Ercoupe BULLETIN

ERCOUPE
SERVICE
BULLETIN

No. **7**

**SUBJECT: Directions for load testing
aileron control system**

fig 1

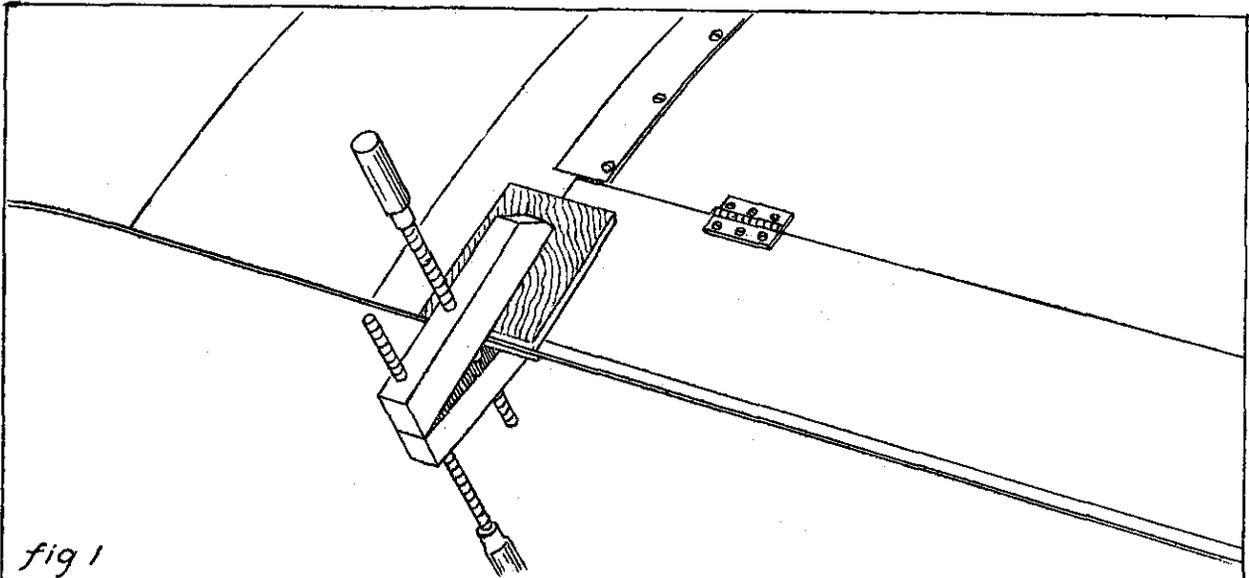
1. Clamp both ailerons even with center section of wing by means of boards and clamps, as shown in Figure 1. (The boards can be bolted together by means of 3/16" bolts if no clamps are available.)

fig. 2

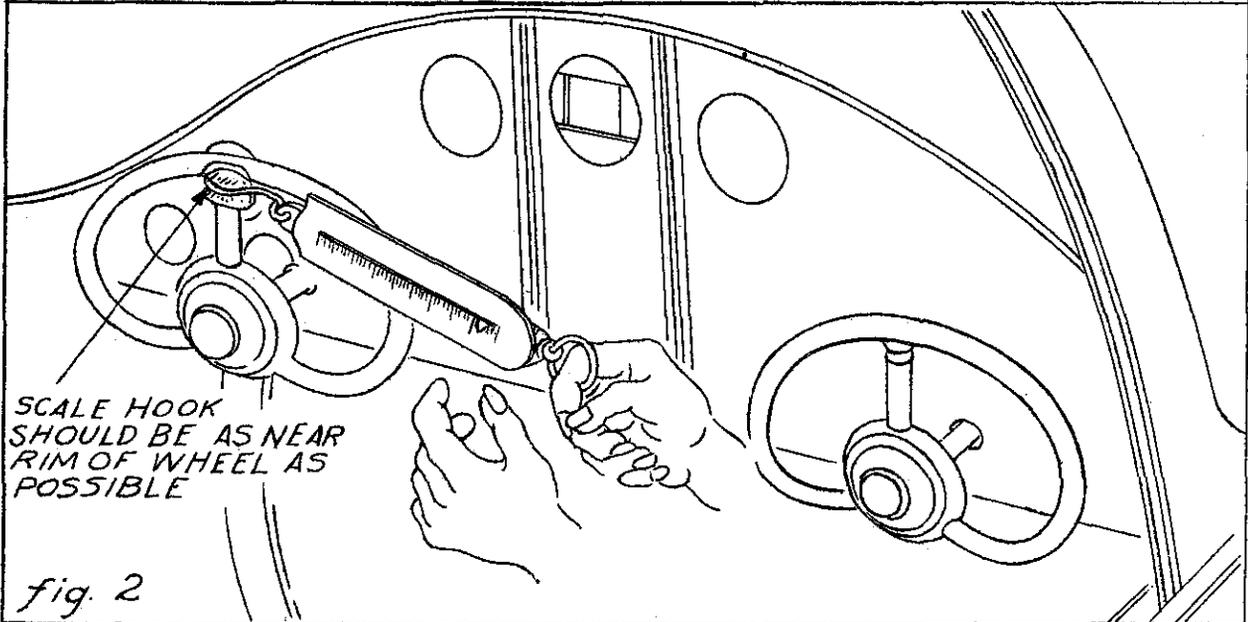
3. Push in the throttle and the hand brake levers to give clearance for test. Place the scale hook around the spoke of left control wheel just inside the rim and use sufficient padding to avoid damage to control wheel, as shown in Figure 2. The wheel should be pulled out from instrument panel just far enough to clear throttle and hand brake levers. Pull scale to right, keeping it at right angles to the spoke of the control wheel, until the scale reads 94 pounds. (Two men may be required.) By the time the full load has been applied the scale will be close to a vertical position, as shown in Figure 3. Do not exceed 94 pounds, because this is merely a proof test and a higher load might damage the control system. As soon as the 94 pound value has been reached slack off gradually until the load is entirely relieved.
